Your ref
BN/61/19/HH

Our ref
PLAN-029389

Proposal: Single storey rear extension, replacement cladding & render finish to east elevation.
Site: BN/61/19/HH: - 6 Wandleys Drive, Eastergate, PO20 3SF.

SOUTHERN WATER

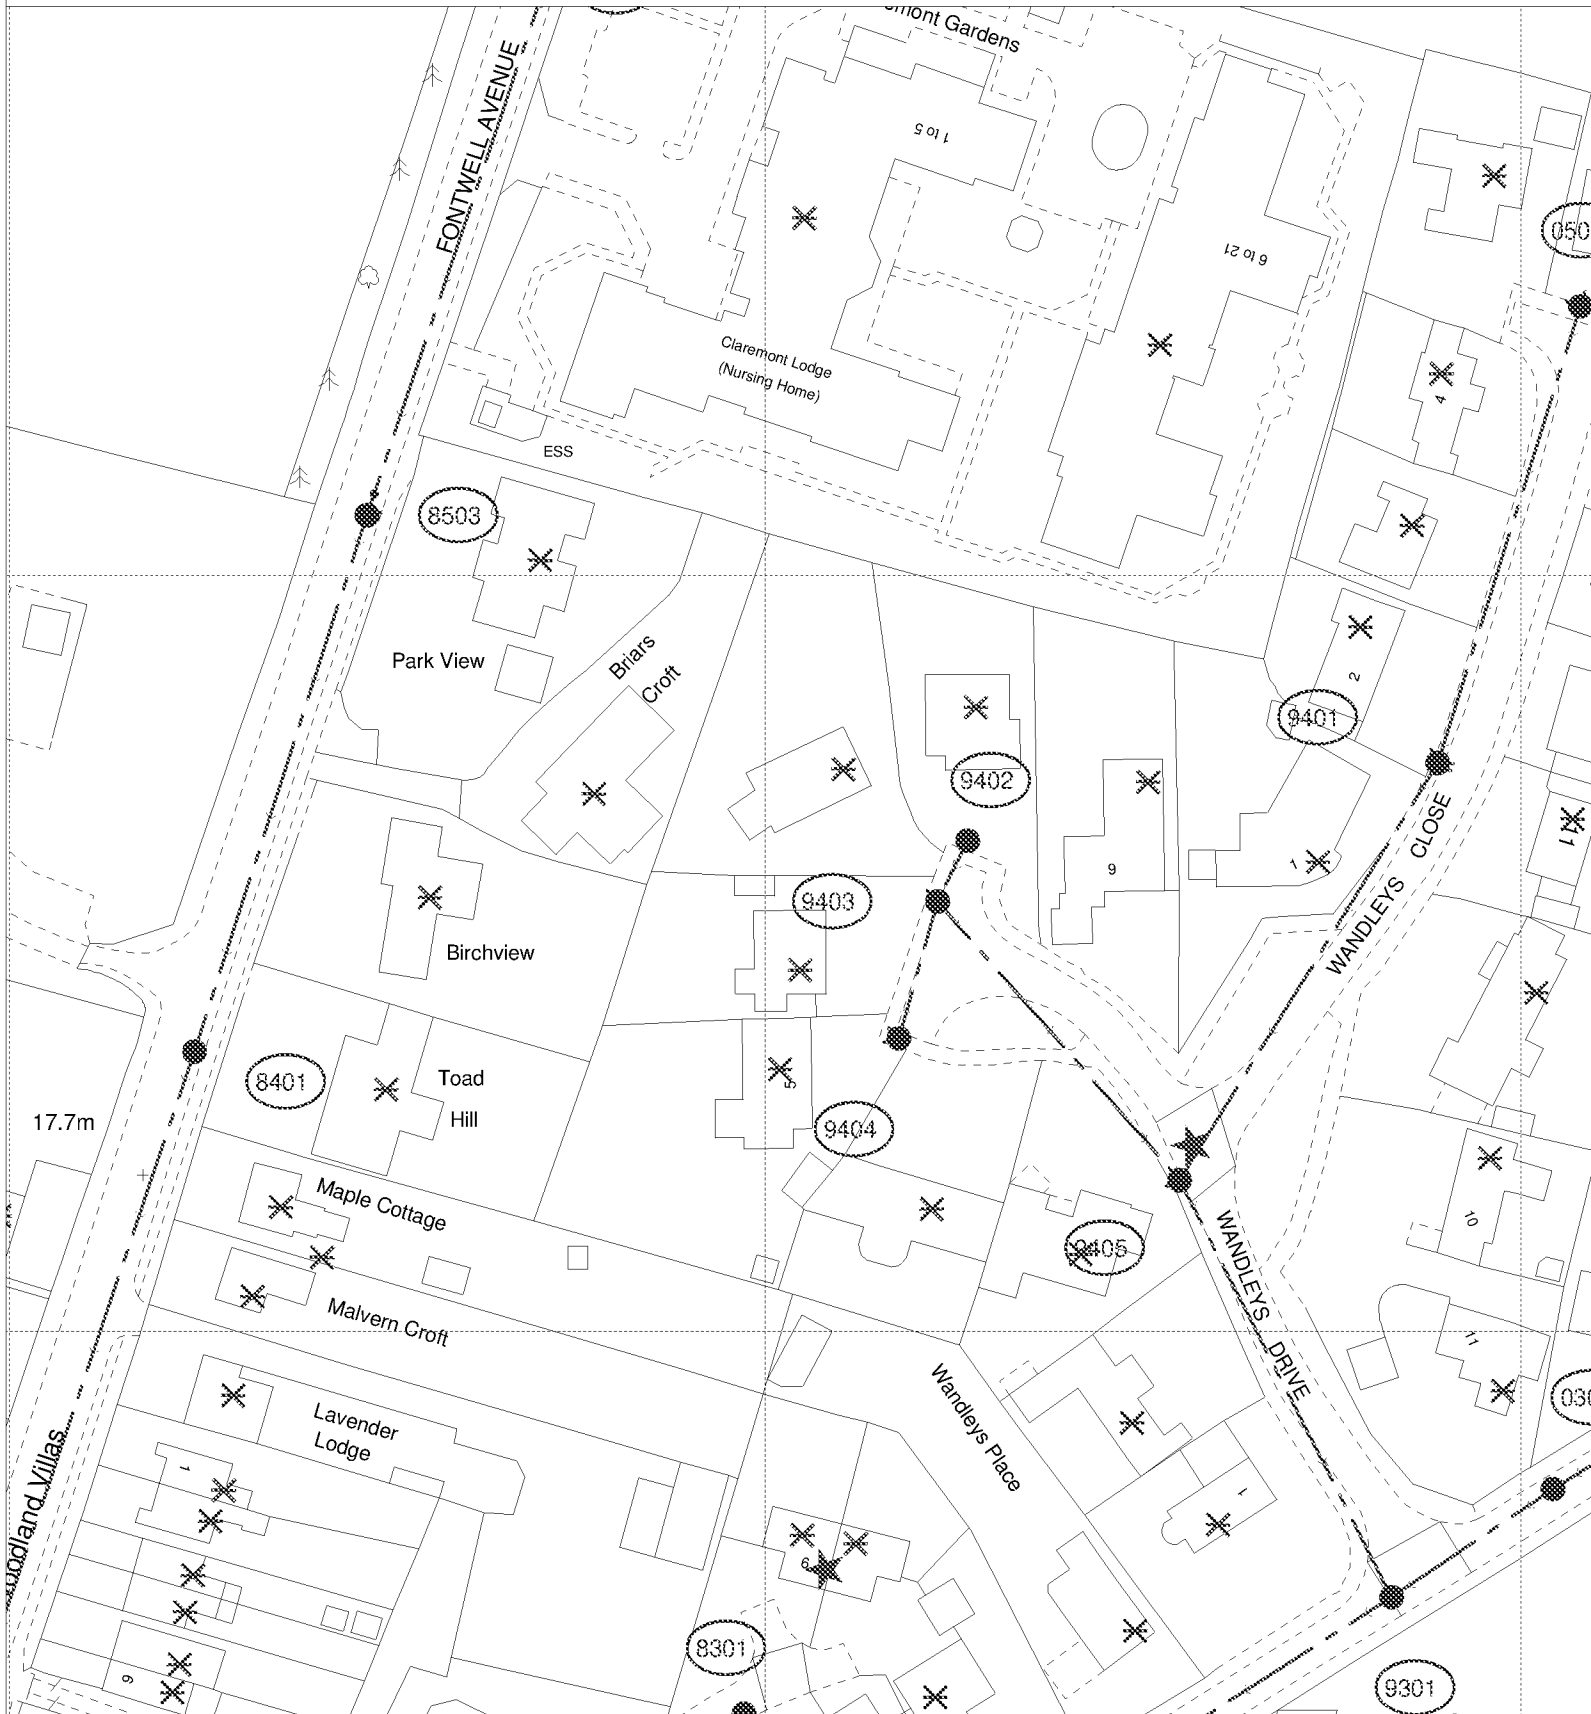
Our initial investigations indicate that there are no public surface water sewers in the area to serve this development. Alternative means of draining surface water from this development are required. This should not involve disposal to a public foul sewer.

It is possible that a sewer now deemed to be public could be crossing the development site. Therefore, should any sewer be found during construction works, an investigation of the sewer will be required to ascertain its ownership before any further works commence on site.
